ADDENDUM NO. 3

Date: September 7, 2018
Project: **Secondary Treatment Plant Upgrade & Recycled Water Expansion**
Job No.: 12600-07/16650-02

The following changes and/or clarifications are hereby made to the Contract Documents, and shall become a part of the Contract Documents dated July 2018.

DECHLORINATION CHEMICAL STORAGE
MECHANICAL SECTIONS

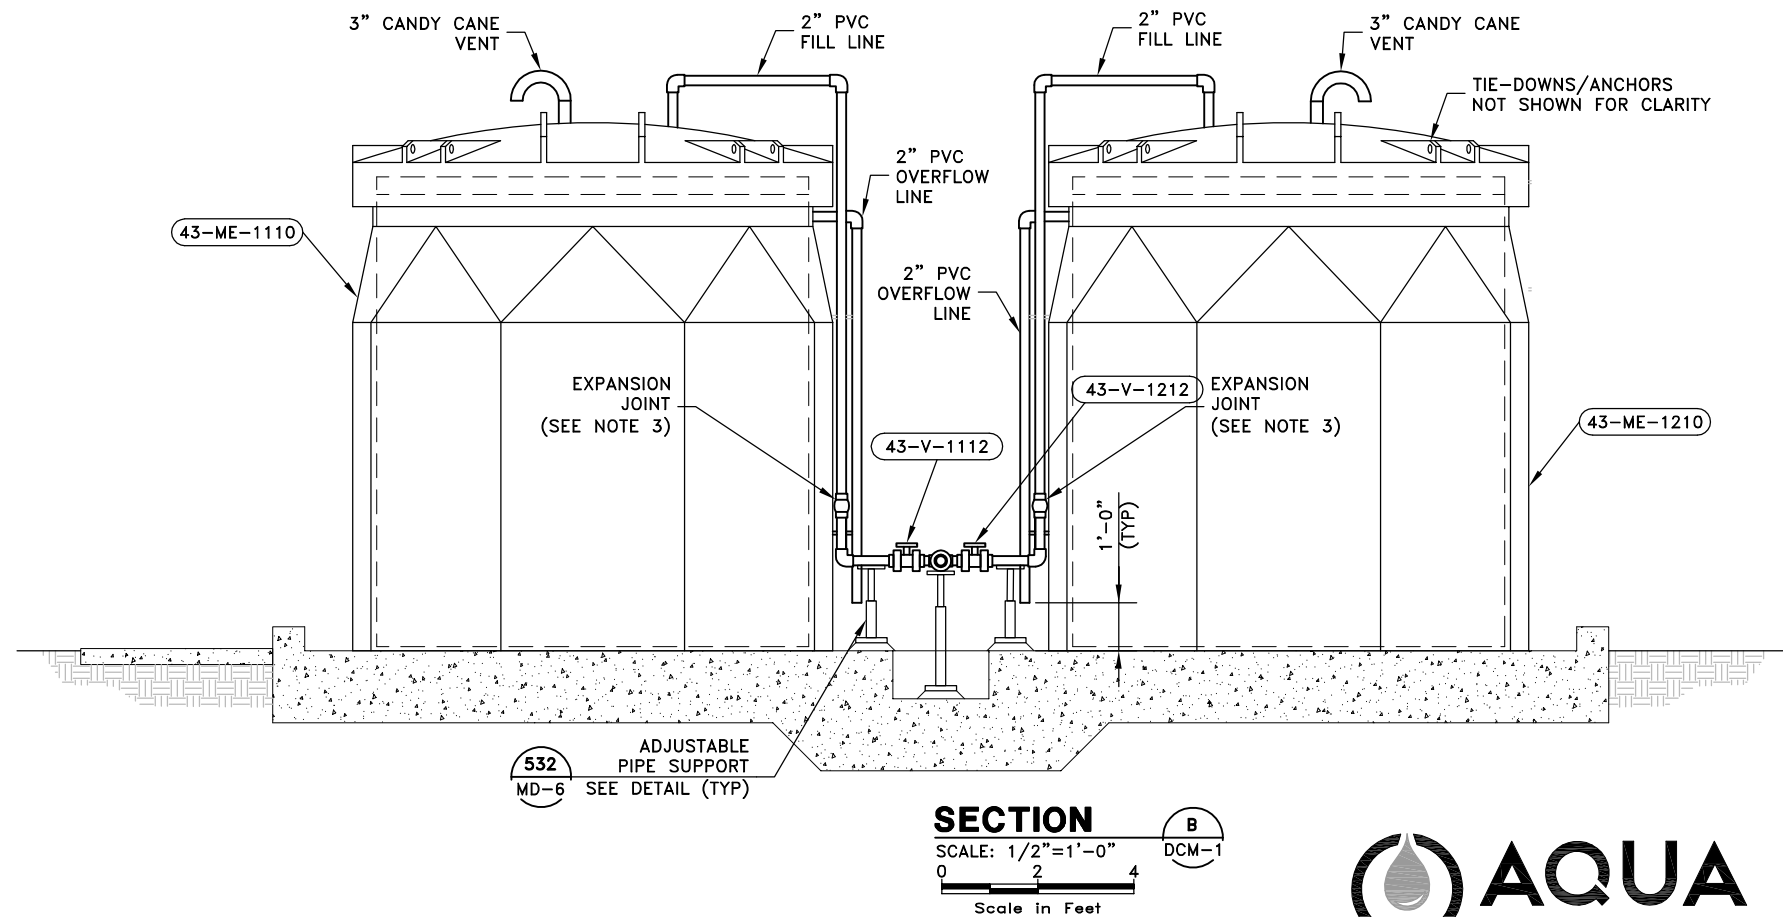
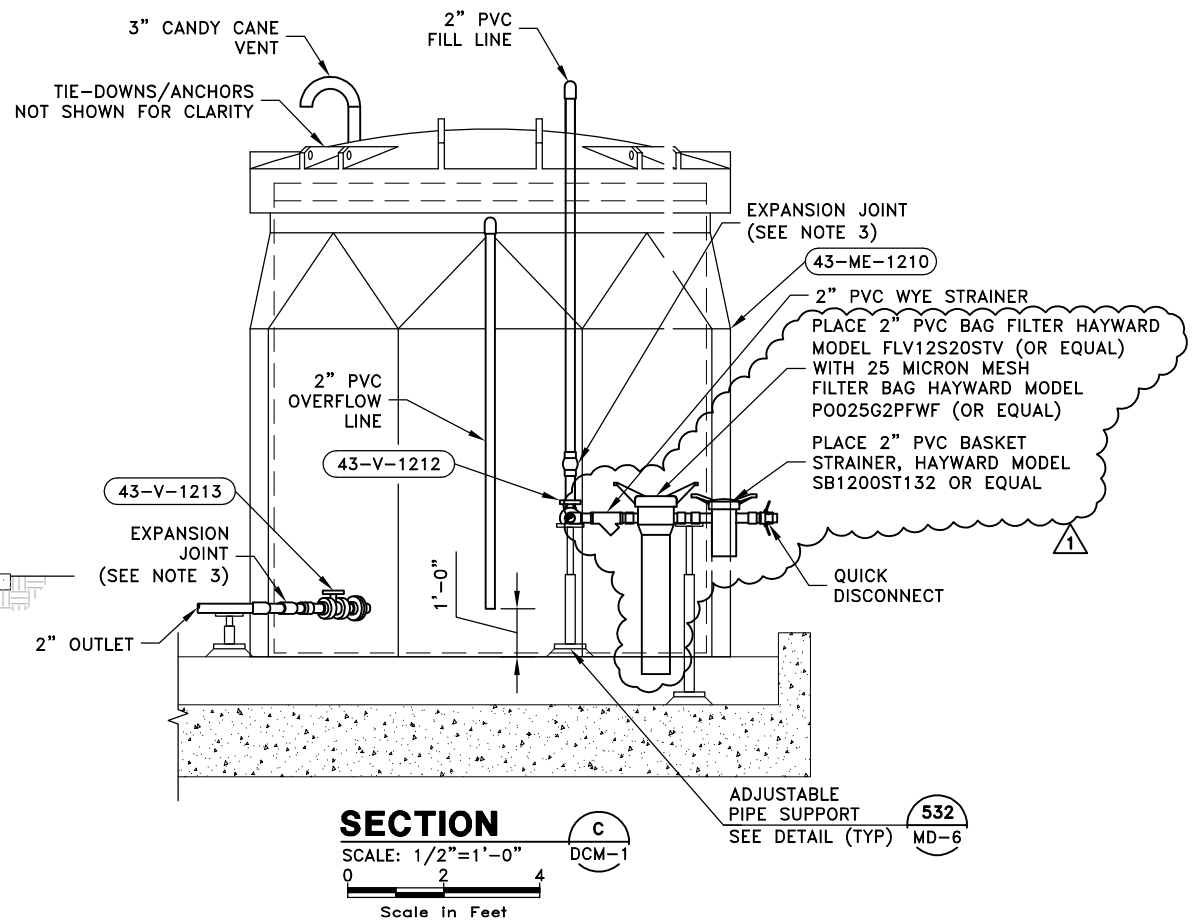
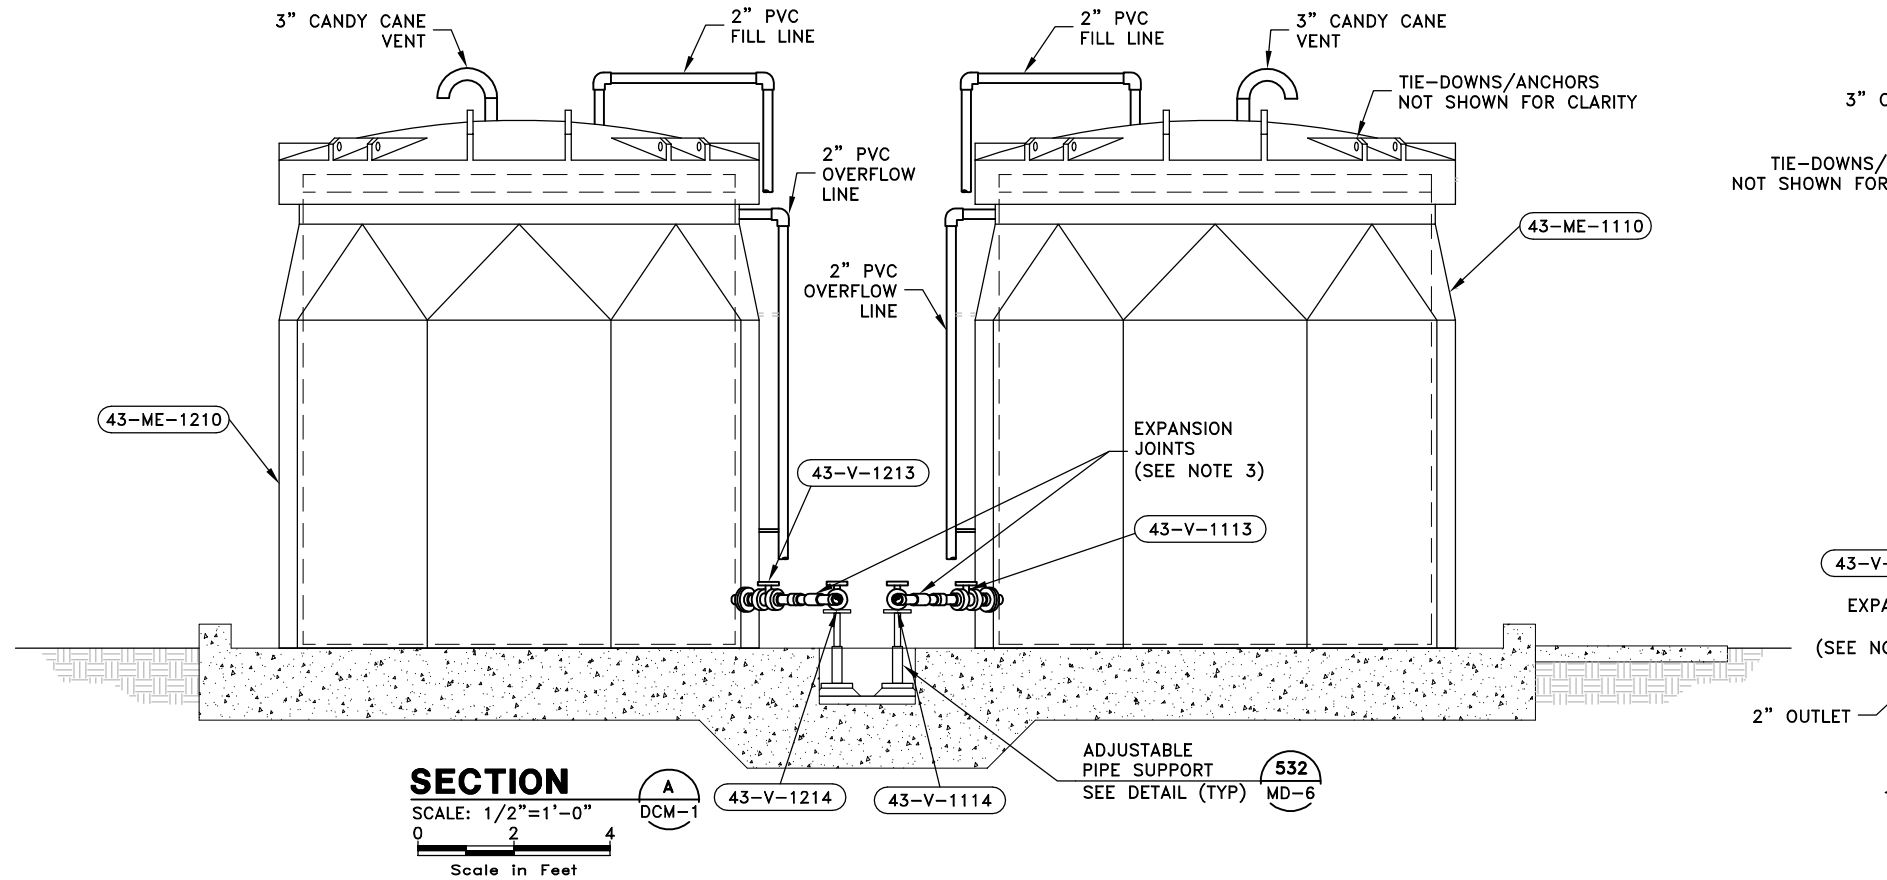
- Bag for Bag Filter: 25 mesh bag model PO025G2PFWF) or equal.
8. **Sheet DCM-1 and DCM-3:** The design of the chemical tank fill line in this area has been revised to incorporate a basket strainer and a bag filter. These additional filters are required as part of this work. The design-basis make/model of the basket strainer and bag filter are noted in the revised drawing and stated again here for reference:

- Basket Strainer -Hayward Model SB1200ST132 (2" PVC basket strainer with 1/32" perforations in CPVC strainer) or equal.
 - Bag Filter – Hayward Model FLV12S20STV (2" PVC basket strainer with Viton gaskets) or equal.

- Bag for Bag Filter: 25 mesh bag model PO025G2PFWF) or equal.

SECTION G
SCALE: 1 1/2"=1'-0" DCM-2
0 3/4 1
Scale in Feet

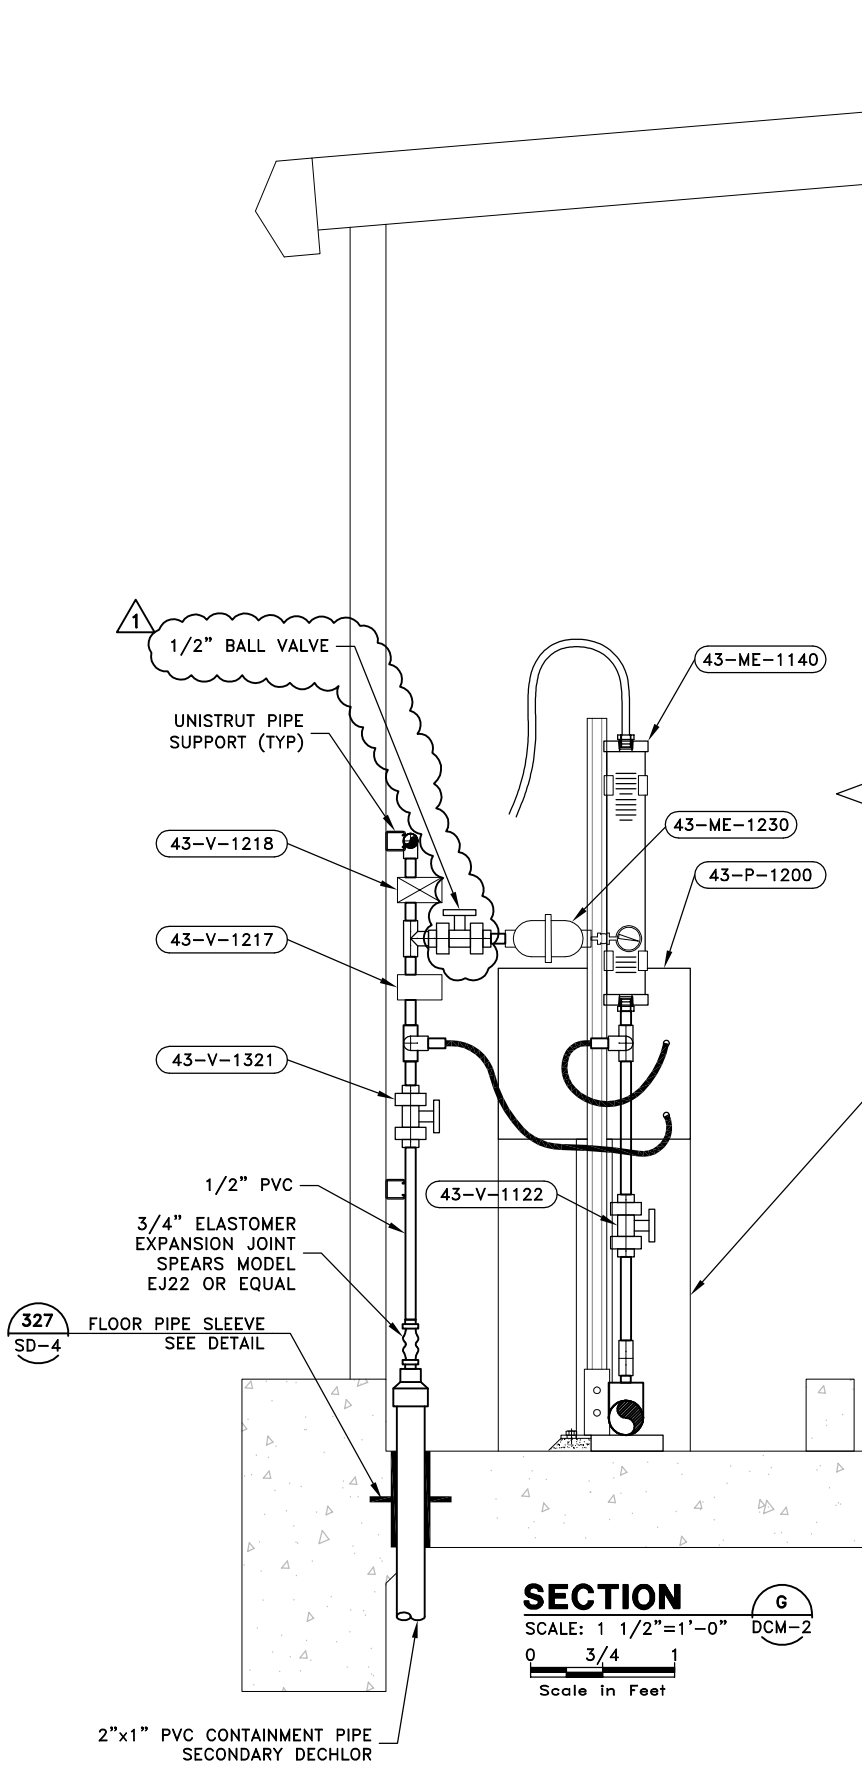
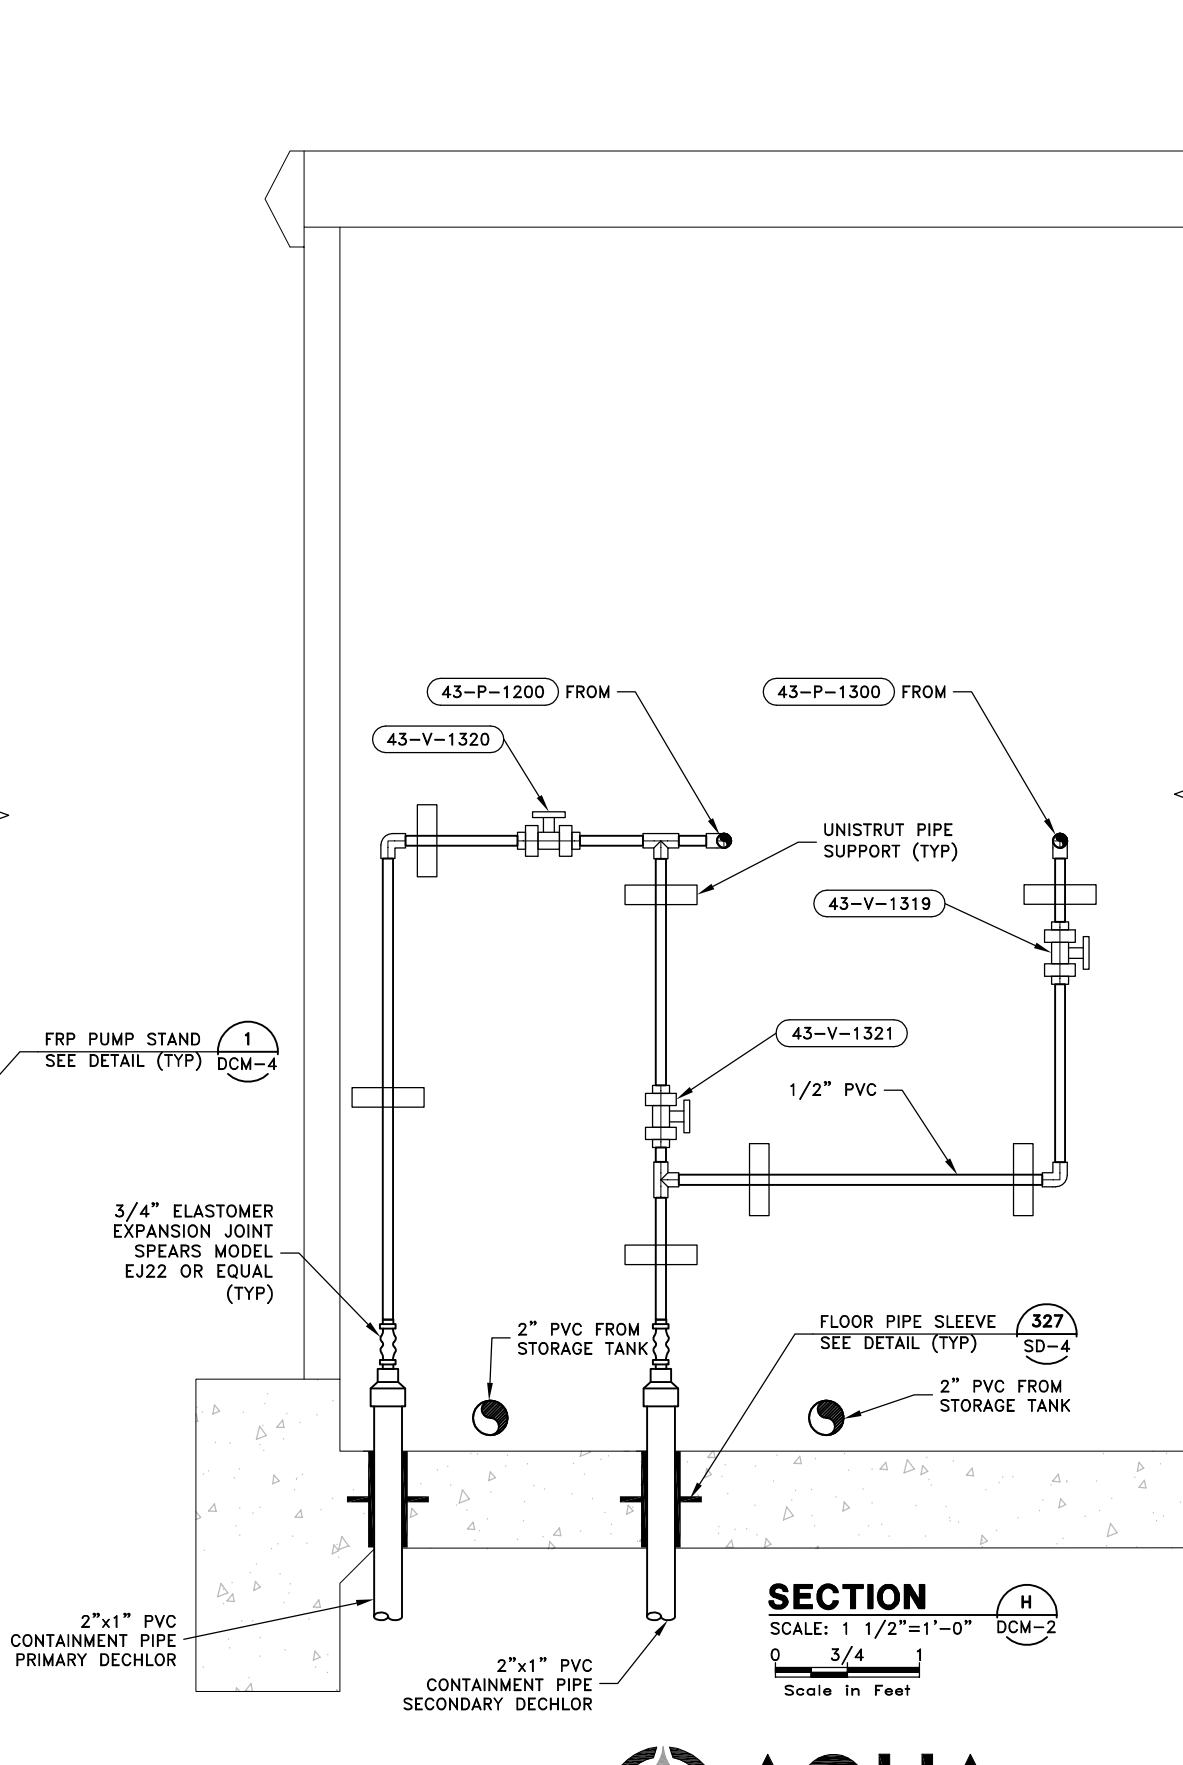
9. **Sheet DCM-7:** ½" PVC isolation ball valves have been added to the pulsation dampeners installed on the chemical pump discharge line. **A revised version of Section G, as shown on sheet DCM-7 is provided with this addendum for reference.** One isolation valve is required for each pulsation dampener (one associated with each pump), for a total of 3 additional ½" PVC ball valves.
